## ADDENDUM # 001

**RE:** Cherokee Nation Entertainment  
Tahlequah Casino

**From:** James R Childers Architect, Inc.  
45 South 4<sup>th</sup> Street  
Fort Smith, Arkansas 72901

## Tahlequah Casino Addendum #01 summary

SHEET NUMBER:  
**S3.3**

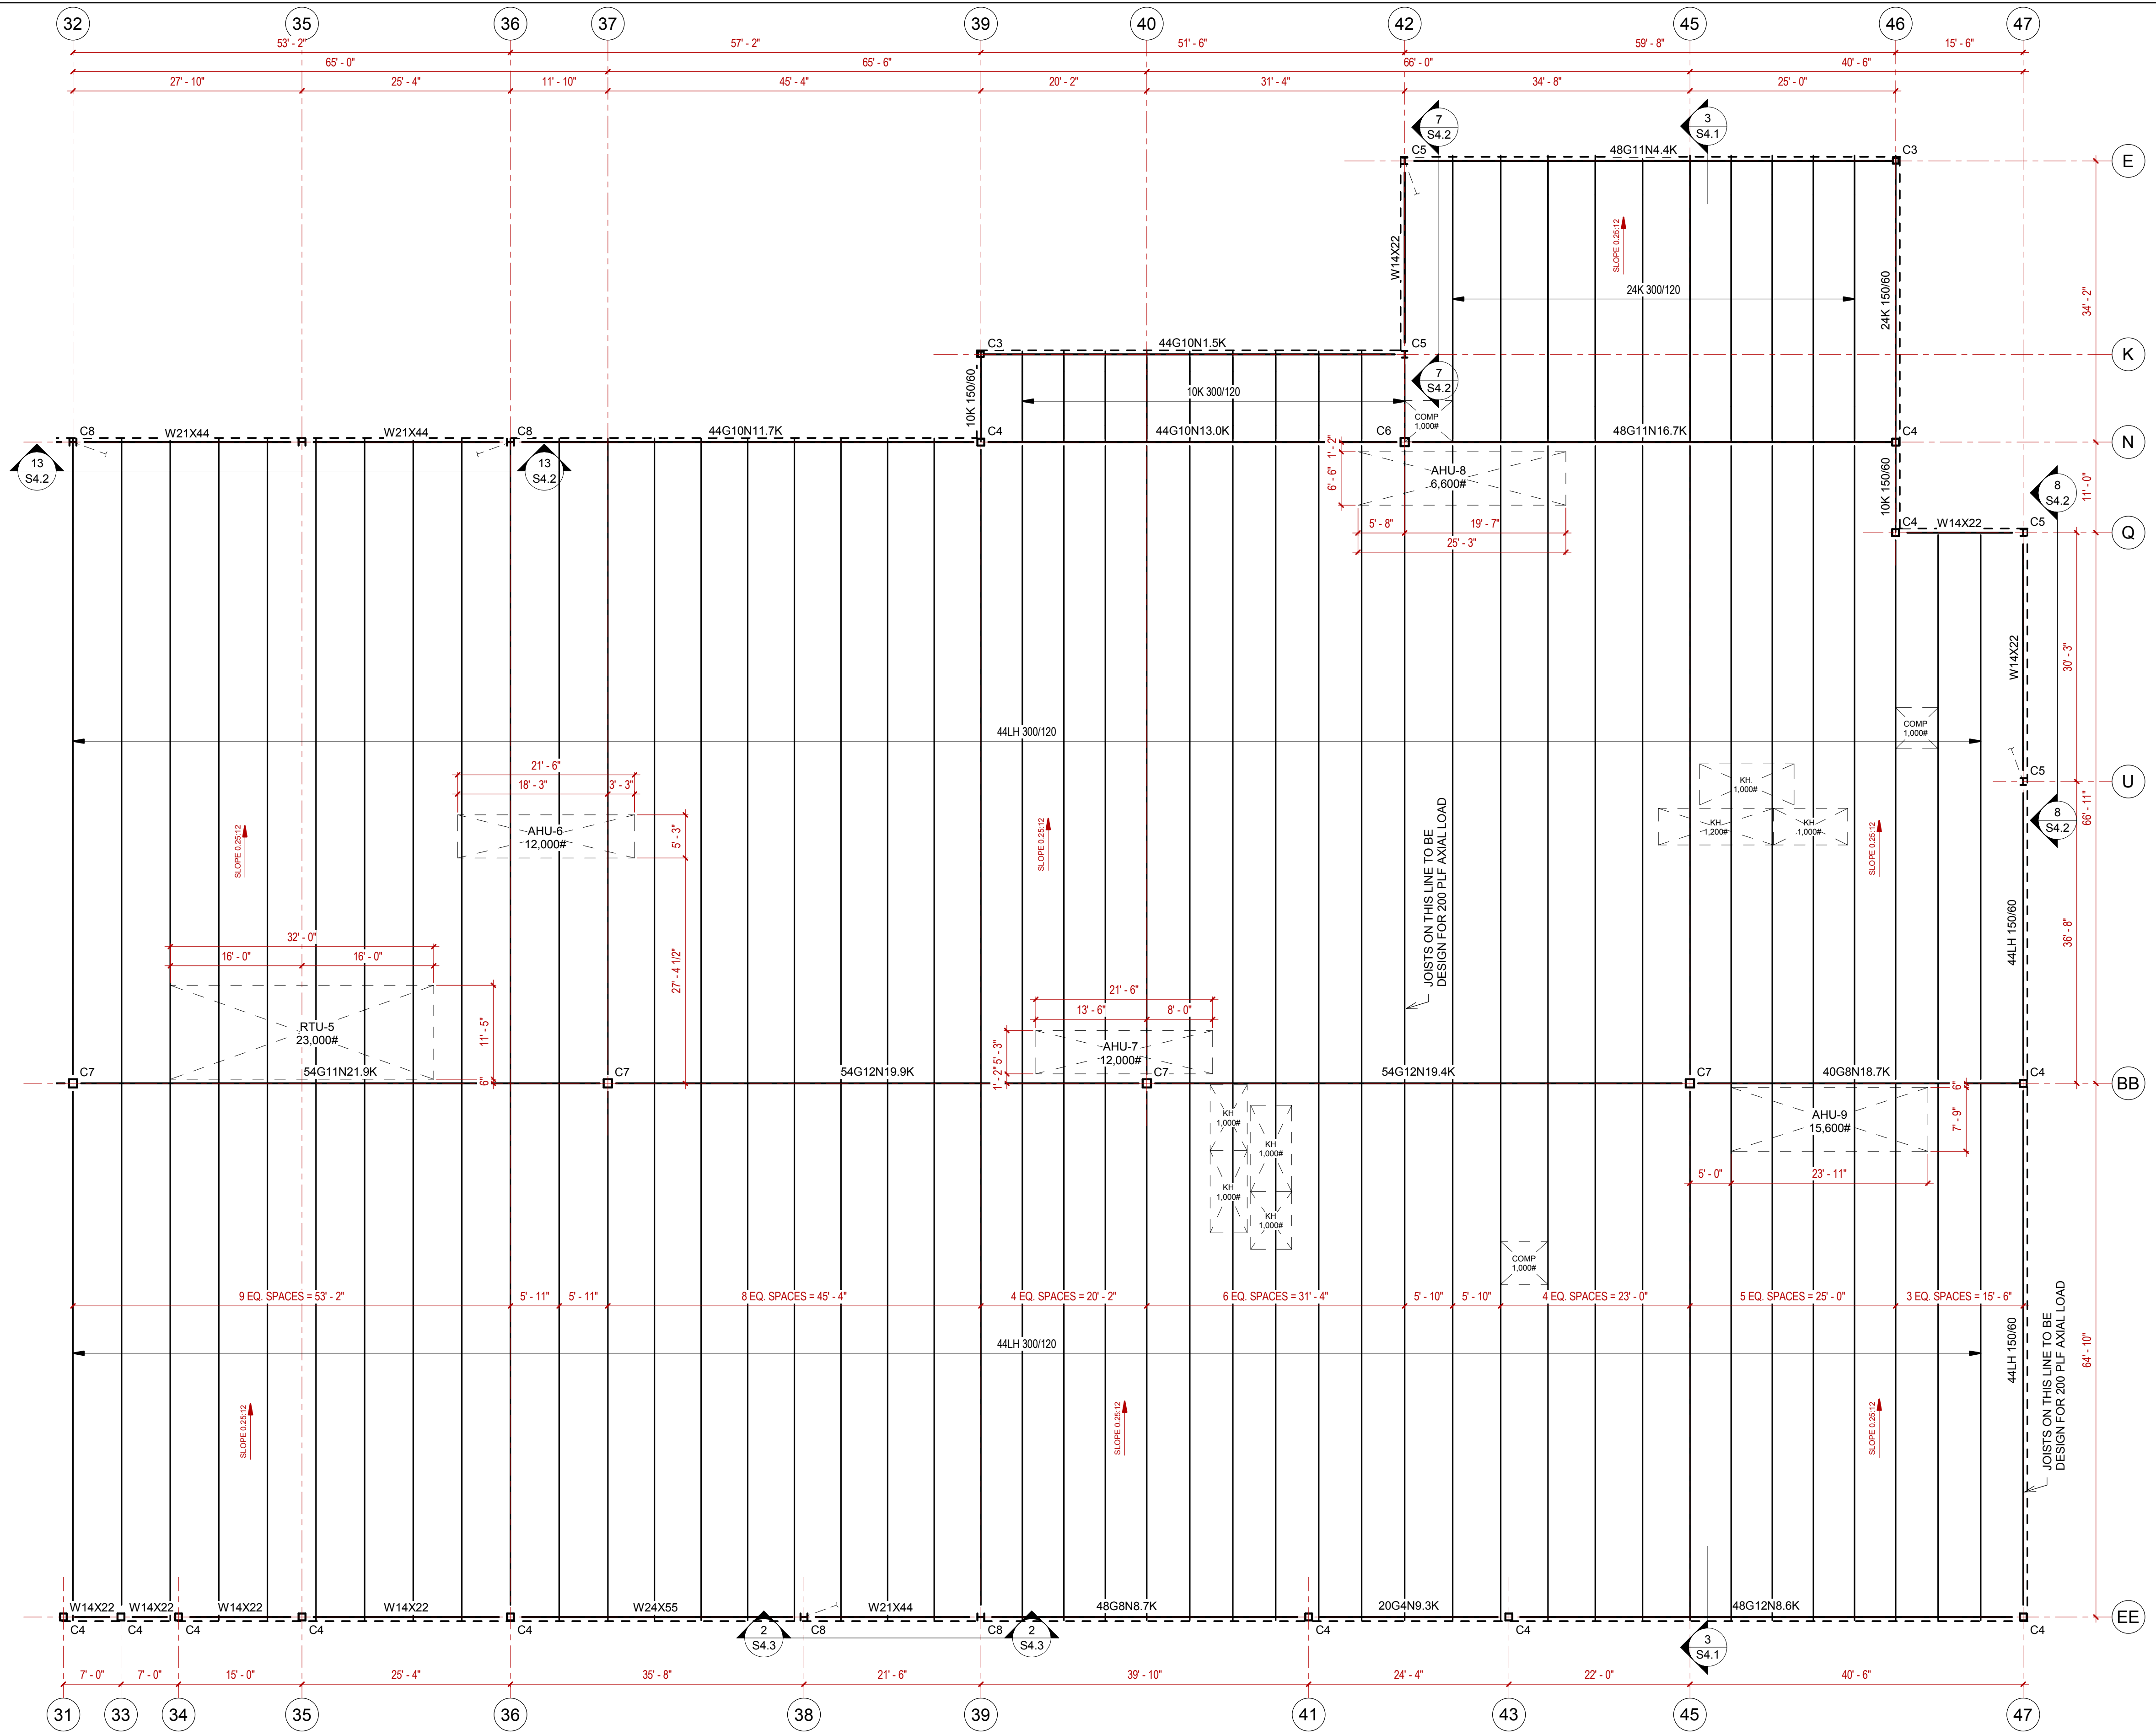
<ul style="list-style-type: none"> <li>• Removed joist girders on gridline 'U'</li> <li>• Revised joist framing. Revised joist girder loadings</li> </ul>
S3.3	<ul style="list-style-type: none"> <li>• Removed brace elevation 42/44-E</li> <li>• Removed column @ E-44</li> <li>• Revised joist framing. Revised Joist girder loadings</li> </ul>
S3.4	Revised detail 7/S3.4
S4.1	Revised section 2/S4.1
S4.2	<ul style="list-style-type: none"> <li>• Revised column size in framing elevation.</li> <li>• Revised brace sizes in framing elevations</li> <li>• Added detail callouts to framing elevations.</li> <li>• Frame elevation moved from grid '19' to '21'</li> <li>• Removed frame elevation @ grid 'E'</li> </ul>
S4.3	<ul style="list-style-type: none"> <li>• Revised column size in framing elevation.</li> <li>• Added detail callouts to framing elevations</li> <li>• Added braced frame details</li> </ul>
S5.1	Added sheet S5.1
